Microstim Case II Comments.

Subject: FW: Microstim Case II Comments - reply

Design review with John Lamb and Peter Anderson on the 16th March 2005. Reply from Samuel Sham to our document "Microstim Case II Comments".

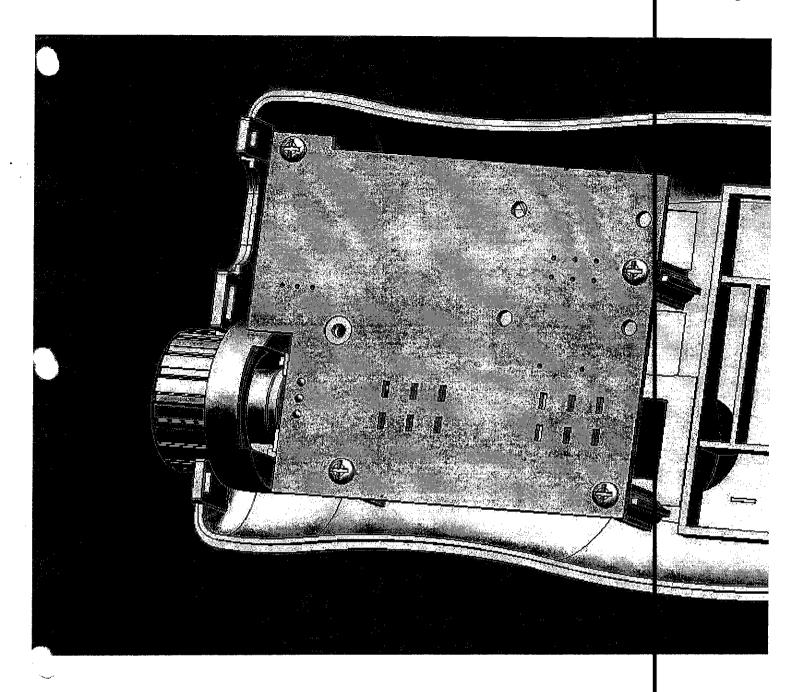
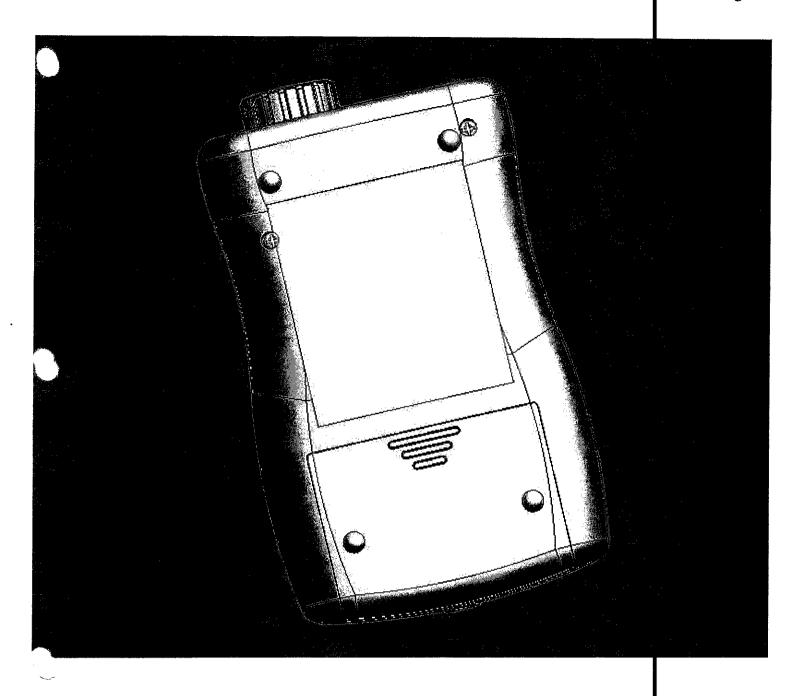
- There are only two fixing screws (below the battery compartment). Should there be two at the top to stop the case springing open?
- Will the case plastic age well or will the moulding deform over time due to fixings stresses? Will the case joins start to come apart if only two fixing screws are used?

- 1. It can be have 2 options: (1) add 1 screw in the label recess area (3 screws.jpg), and (2) add 2 screws at asymmetrical position (4 screws.jpg). Please check per the attached and confirm.

¹ Please add 2 screws in the asymetrical position (4 screws.jpg).

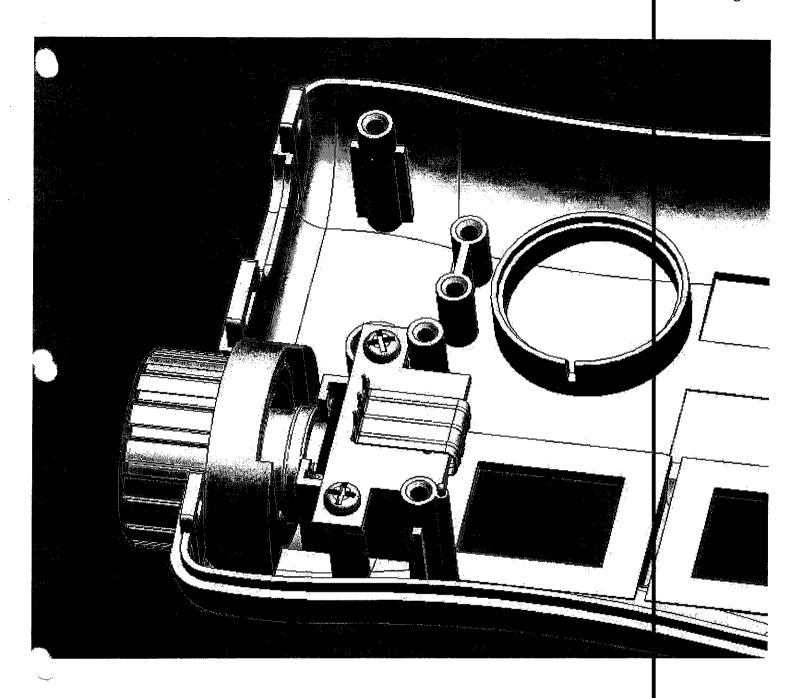
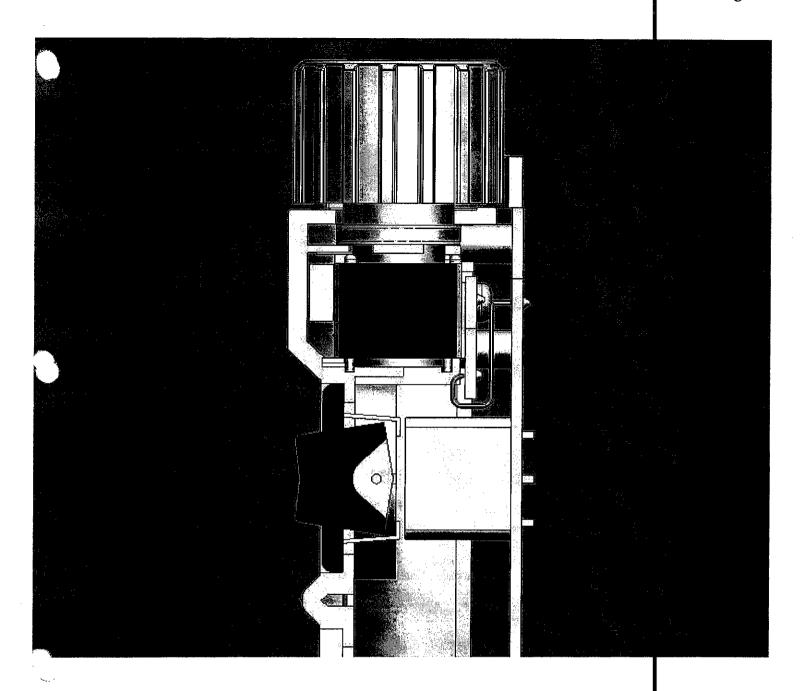
- The battery compartment floor needs to be solid so that a label can be stuck on serial number and battery type.
- How will the knob be attached to the pot? Will it be screwed as at the moment? Will the screw show?

Øcc.
- √ 7. A plastic Knob Base was welded with Knob together and sits on the shaft of pot. Two round ribs from Top and. Bottom case will locate the pot thread neck area firmly. (knob.jpg) Can knob 0 Pot be remark

7 Can the knob be removed from the pot if the pot has to be replaced?
